BROCKTON HEIGHTS
NO. 5
M.B. 31/31.32
BROCKTON HEIGHTS NO. 4
M.B. 30/63,64 REC. RIV. CO.
SHERMAN DRIVE
Const. 6" curb and gutter, Std. #108
Const. 6" Dbl. Gutter
Const. return, aprons and dbl. gutter.
Join Existing Return & Curb
See Detail
Curb Return Data
B.M.: EL. 756.98 ON S&L IN SW CURB RETURN SHERMAN & GARFIELD.
F.B.: 593/56, 606/10
SHERMAN DR.
GARFIELD ST.
Join Existing Curb
NOTE:

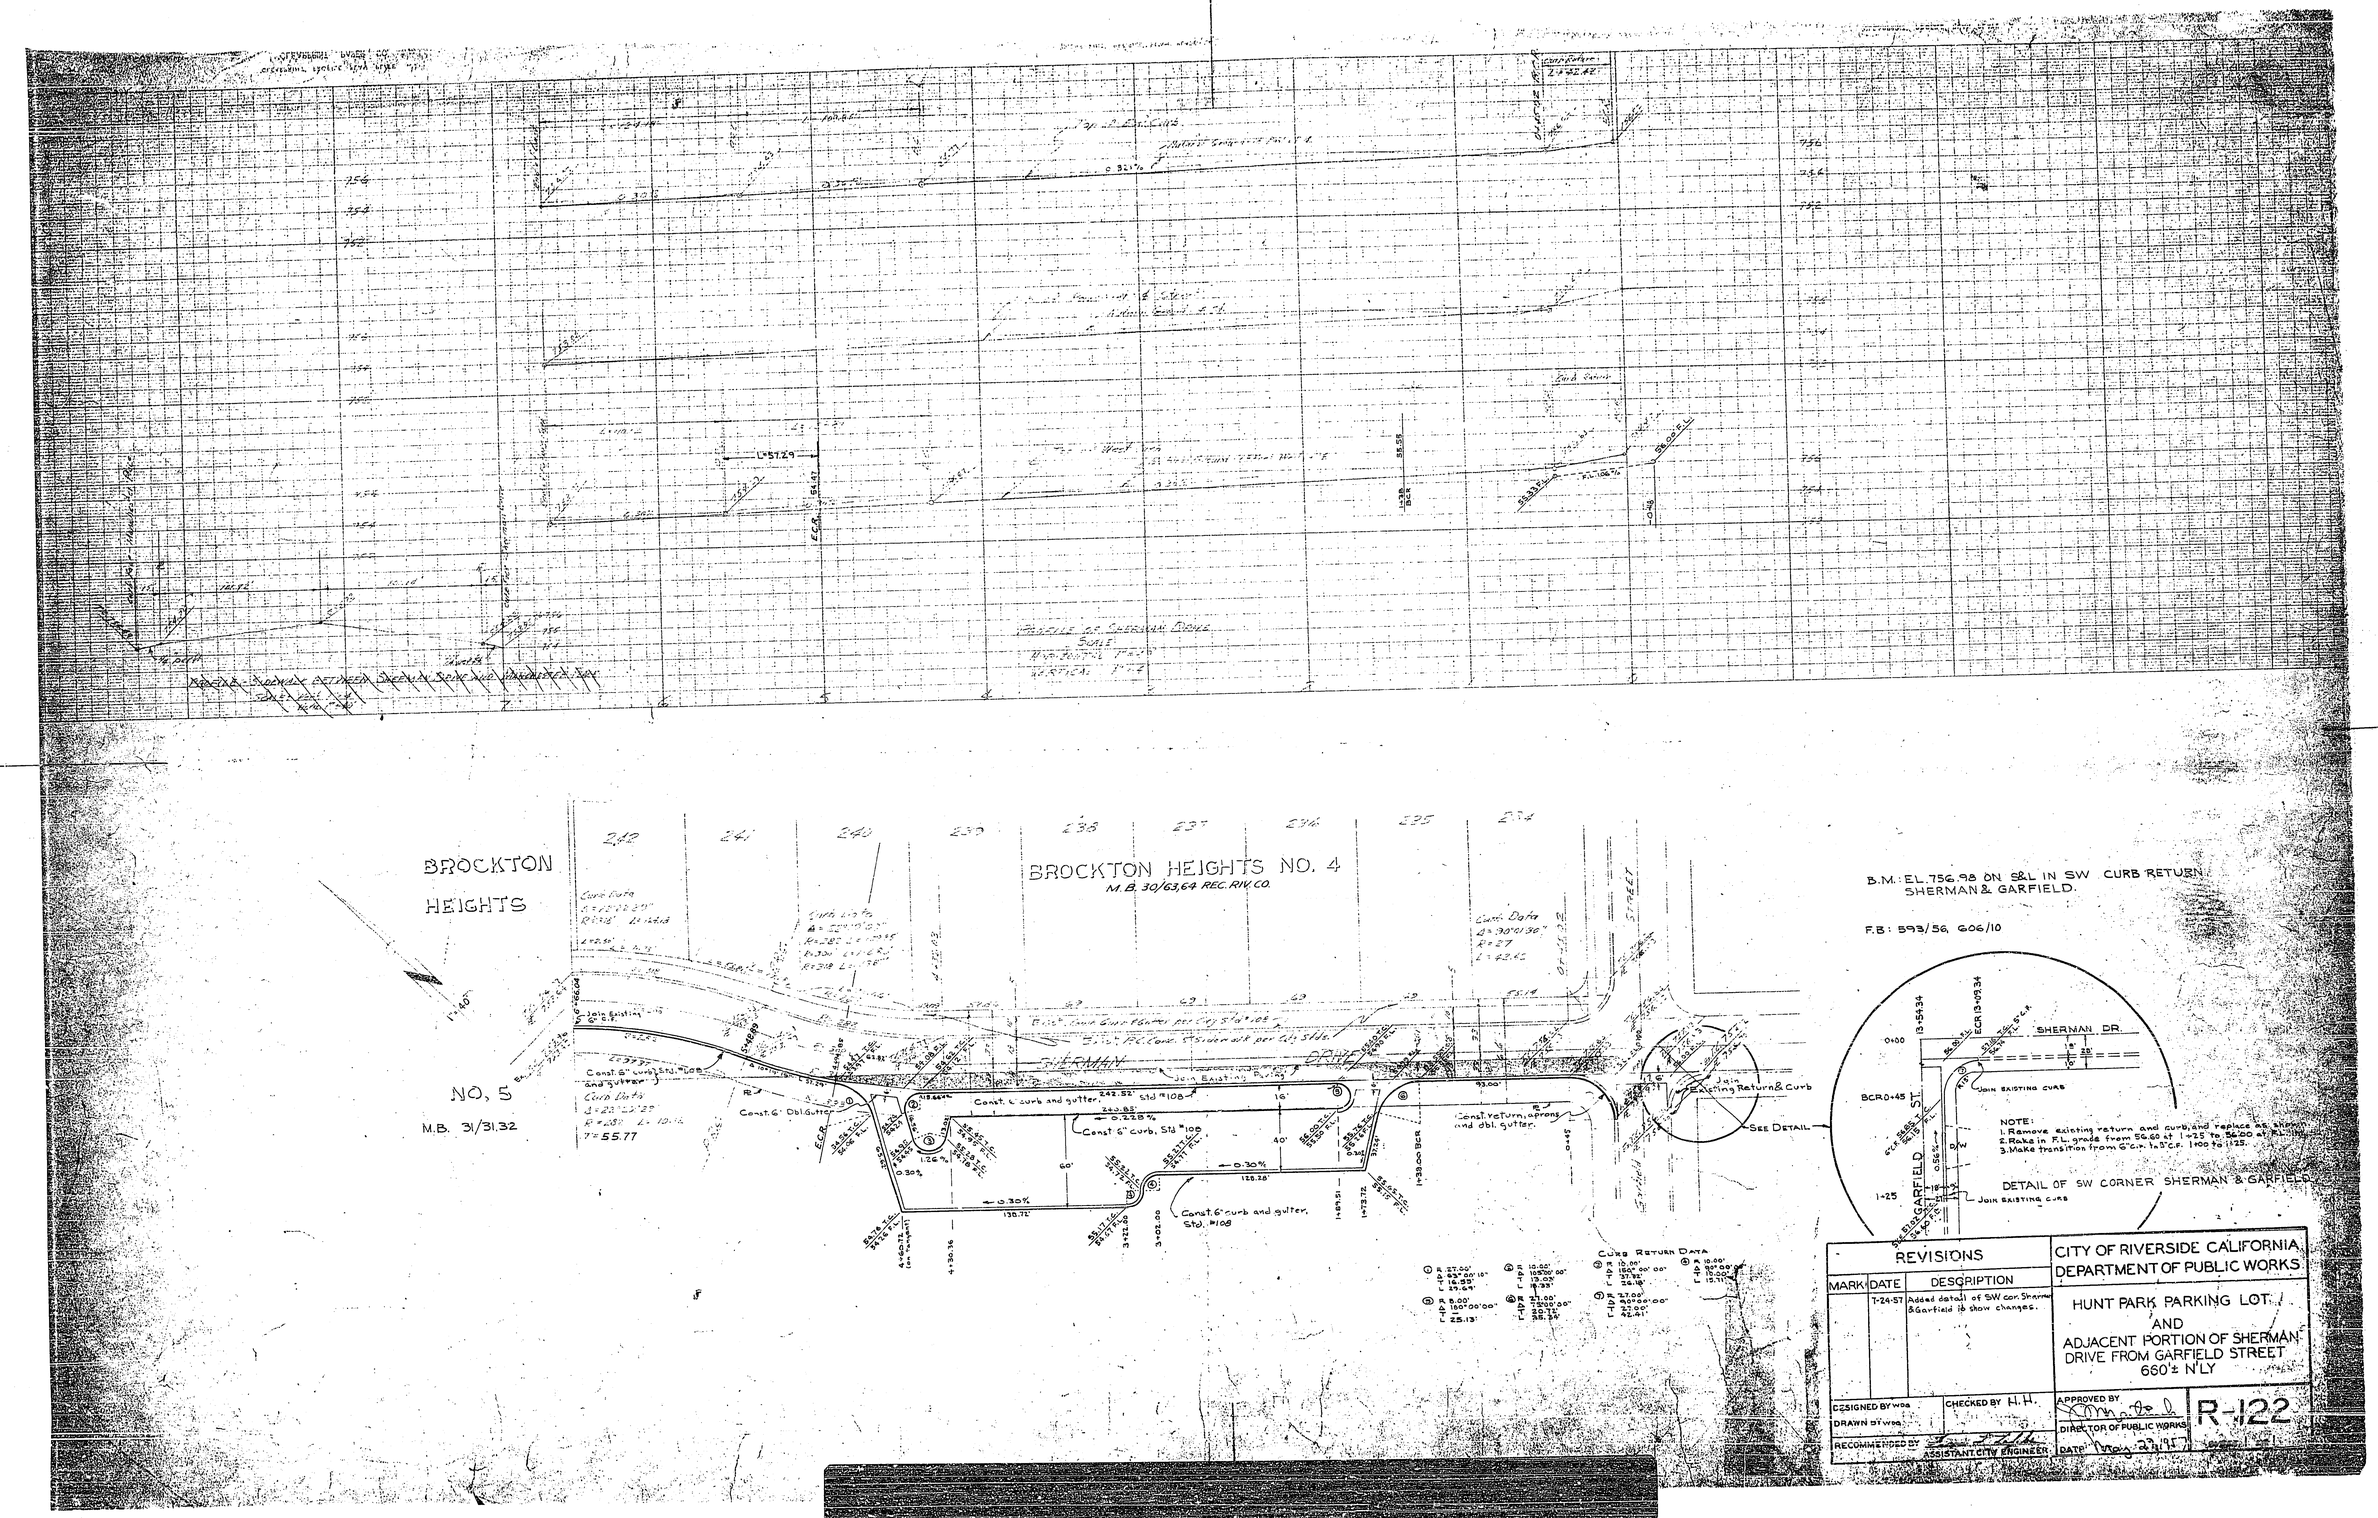
1. Remove existing return and curb, and replace as shown.
2. Rake in F.L. grade from 56.60 at 1+25 to 56.00 at F.L.
3. Make transition from 6" c.r. to 5" c.r. 1+00 to 1+25.
DETAIL OF SW CORNER SHERMAN & GARFIELD
REVISIONS
MARK
DATE
DESCRIPTION
7-24-57
Added detail of SW cor. Sherman & Garfield to show changes.
CITY OF RIVERSIDE CALIFORNIA
DEPARTMENT OF PUBLIC WORKS
HUNT PARK PARKING LOT
AND
ADJACENT PORTION OF SHERMAN DRIVE FROM GARFIELD STREET
660'± N'LY
DESIGNED BY WDG
DRAWN BY WDG
CHECKED BY H.H.
RECOMMENDED BY
ASSISTANT CITY ENGINEER
APPROVED BY
DIRECTOR OF PUBLIC WORKS
DATE May 23, 1957
R-122
